City of Santa Fe, New Mexico

DATE: April 25, 2023
TO: Historic Districts Review Board Members
FROM: Heather Lamboy, Assistant Director, Planning & Land Use Department

Case # 2023-006360-HDRB

Address: 502 Cerrillos Road
Historic Status: Non-Contributing
Historic District: Historic Transition

EXISTING EAST ELEVATION

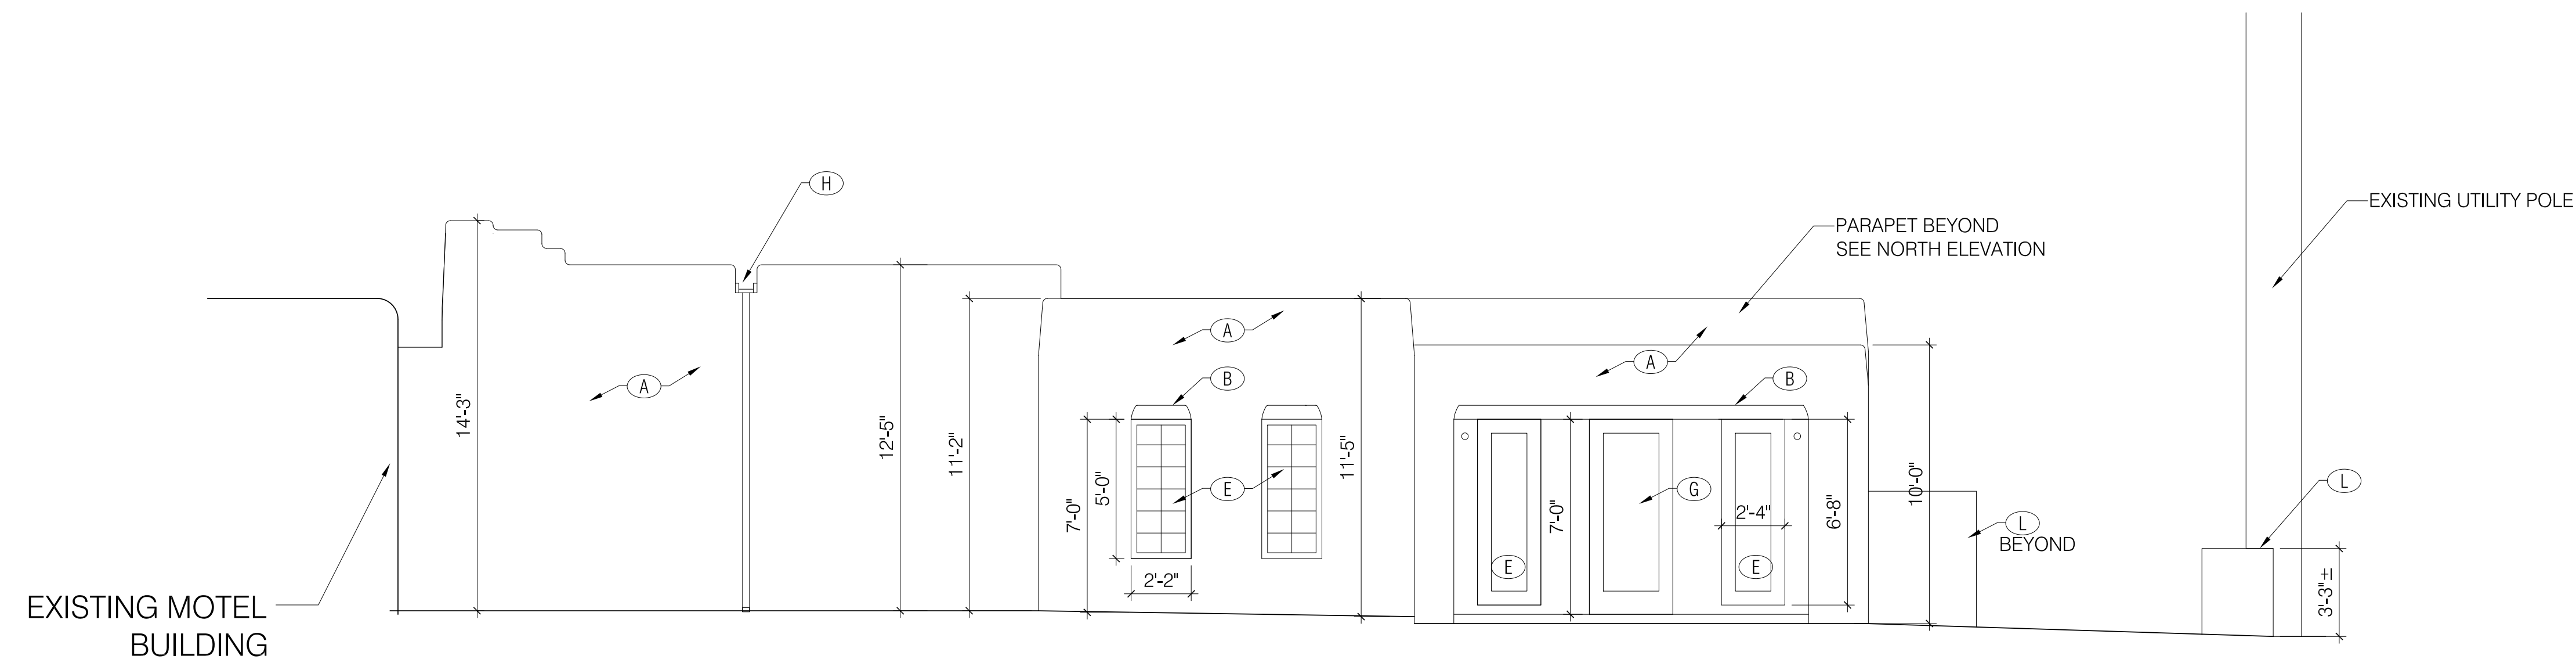
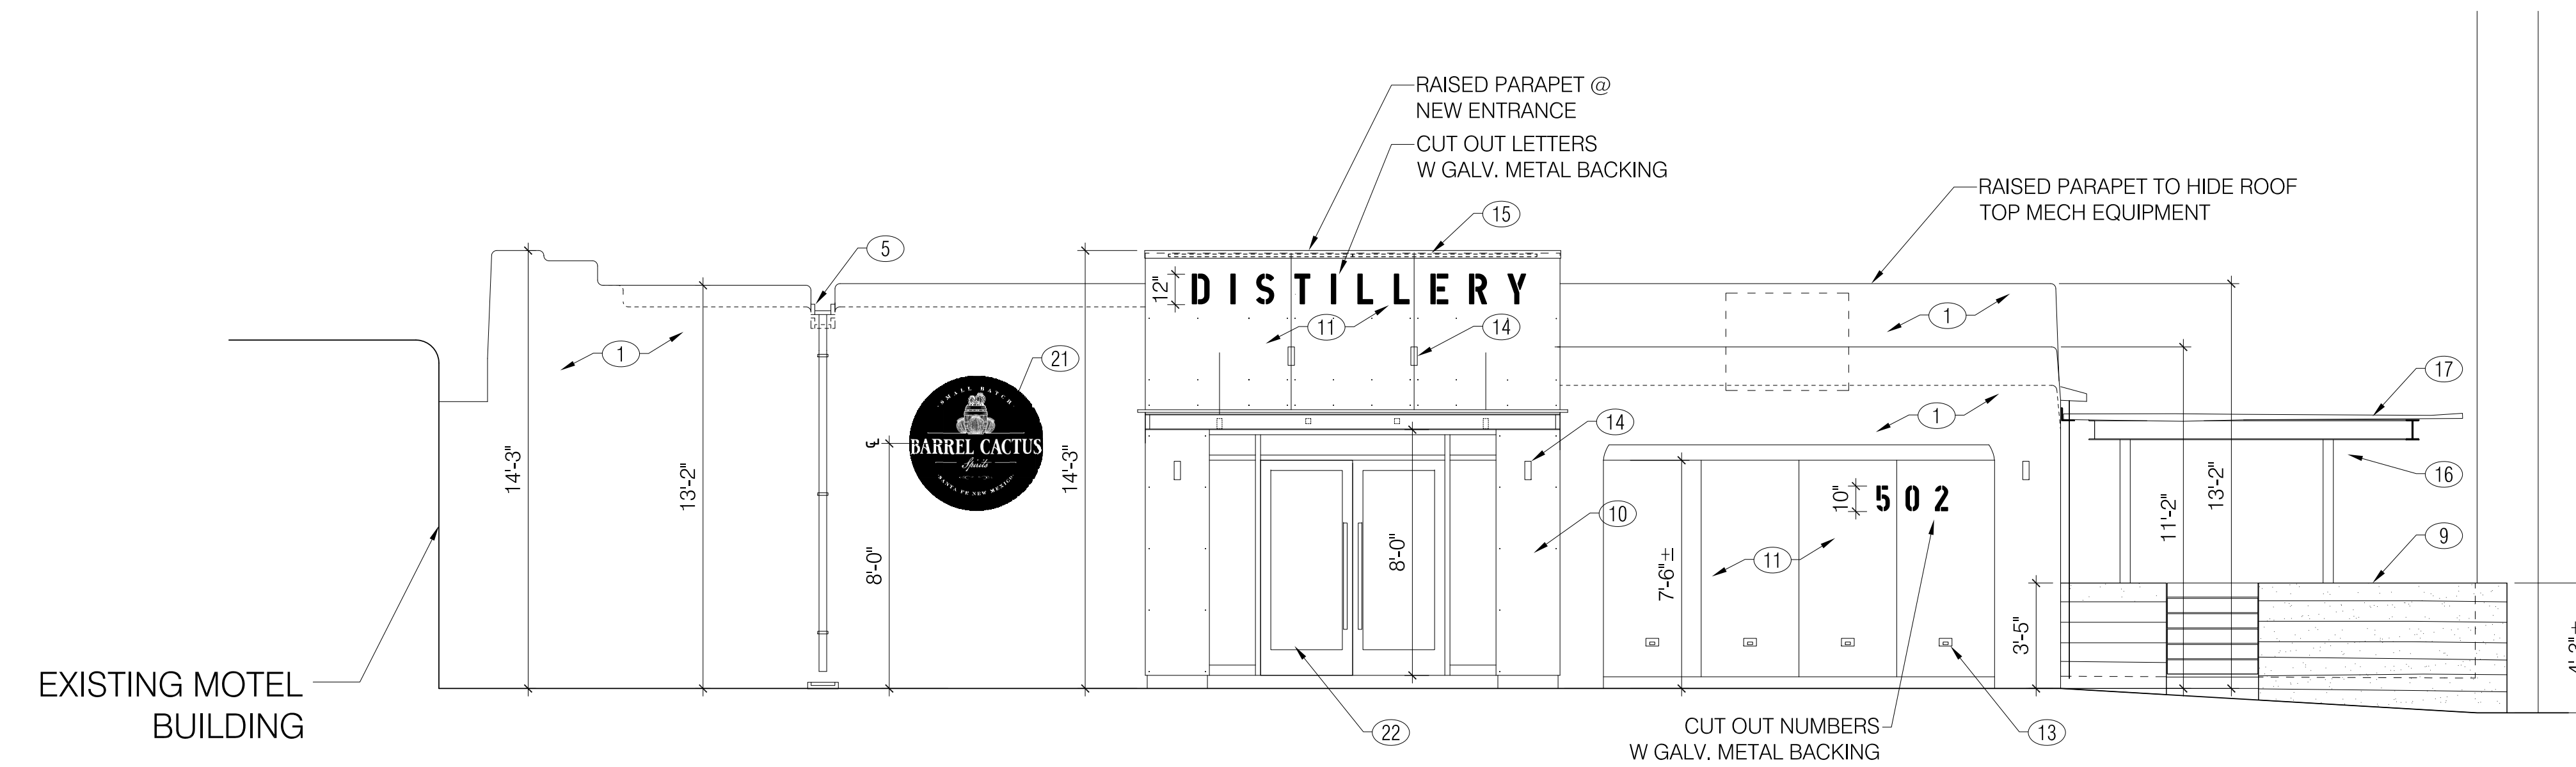
The applicant proposes to retain the existing portal's lintel and enclose it with 16 GA rusted steel plates with cut outs for signage. The applicant states that steel details are used on other buildings within the Historic Transition District for both signage and canopy features. Photographs have been provided. While steel is used as an accent material, it is not used for an entire wall. Staff suggests using steel as an accent material and include windows or stucco as a predominant part of this elevation.

Exception to Section 14-5.2(D)(4): Applicant requests an exception to permit the enclosure of the existing portal on the east elevation.

Staff Response: As designed, the predominantly metal feature is not consistent with the overall character of the district. Staff suggests using metal as an accent material and utilize either windows or stuccoed insets.

Staff Response: While moving the main entrance has merit in providing better access to the building, the reason of the hardship to the applicant has not been stated.

Staff Response: While previous portal enclosures have been permitted in the district, none of them have a wall of sheet metal. This is a design feature not found in the district.

Member Aguilar Medrano said the first question is whether the Board would approve the metal siding, which is clearly not allowed, even in this district. She understood this is on the cusp of the Transition District and a building could be close by that has steel.

Mr. Fitzgerald referred to the front elevation, east. He said they will remove that entrance that is clad in steel. The infill has metal panels with the street address cutout as a way to bring the graphics into it with the street numbers and distillery.
